11-SD-78
PM 15
Valiano Development DEIR

The California Department of Transportation (Caltrans) has reviewed the Draft Environmental Impact Report (DEIR) for the Valiano Specific Plan project located near State Route 78 (SR-78). Caltrans has the following comments:

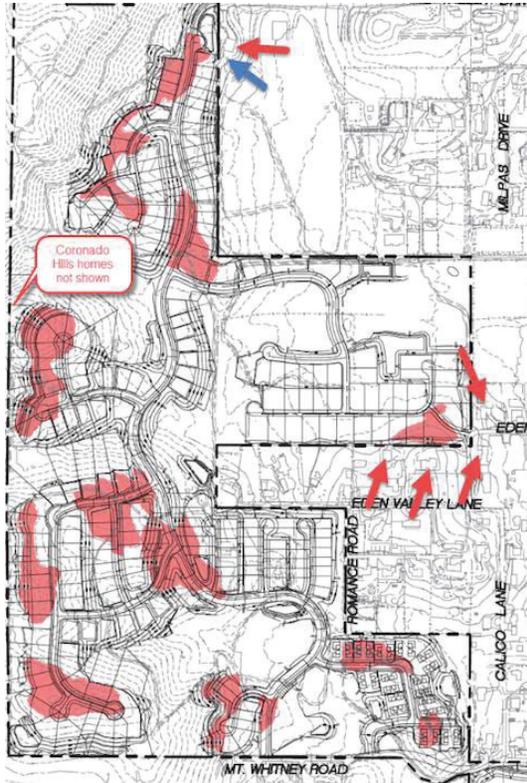
K-151 The diagram included in the DEIR does not show the homes on Coronado Hills in San Marcos - yet by referencing other maps it appears blasting is proposed right below existing homes, conveniently located in another jurisdiction which does not get to decide on the project approval outcome. See, Exhibit A for further reference to Coronado Hills homes.

K-151 Figure 2 in the AAR shows the areas surrounding the Project, similar to the map within the Exhibit A of the commenter's letter. In Section 2.6.1.4 of the EIR, existing noise-sensitive land uses in the Project vicinity are described, which include areas north, east, and west of the Project site. Mitigation applies to any construction activities within the setback distances described in the measures (see Response K-150a). No comments were received from the City of San Marcos regarding blasting and/or noise issues.

VALIANO
 RPO BUFFERS AND FUEL
 MODIFICATION ZONES
 SHEET 6 OF 6
 AUGUST 8, 2014

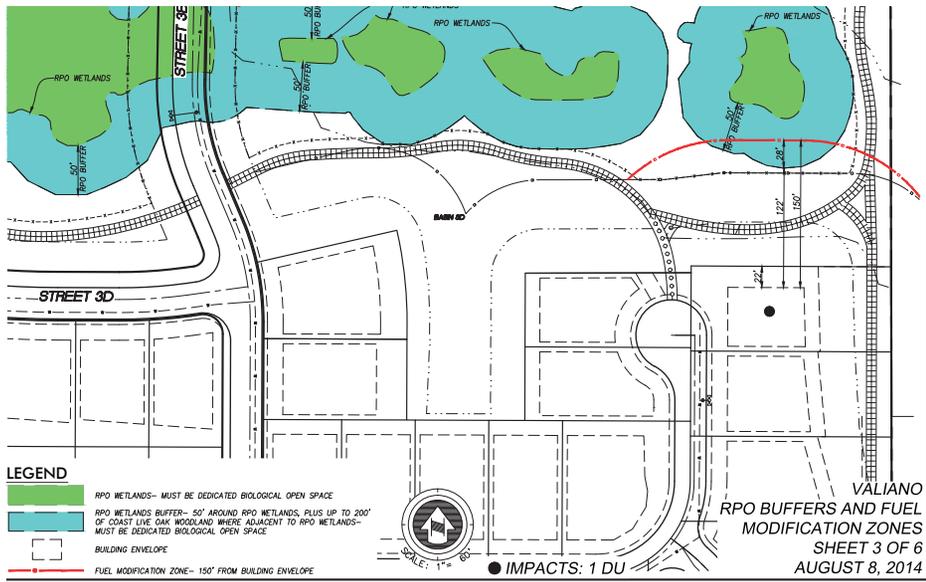
- RPO WETLANDS— MUST BE DEDICATED BIOLOGICAL OPEN SPACE
- RPO WETLANDS BUFFER— 50' AROUND RPO WETLANDS, PLUS UP TO 200' OF COAST LIVE OAK WOODLAND WHERE ADJACENT TO RPO WETLANDS— MUST BE DEDICATED BIOLOGICAL OPEN SPACE
- BUILDING ENVELOPE
- FUEL MODIFICATION ZONE— 150' FROM BUILDING ENVELOPE
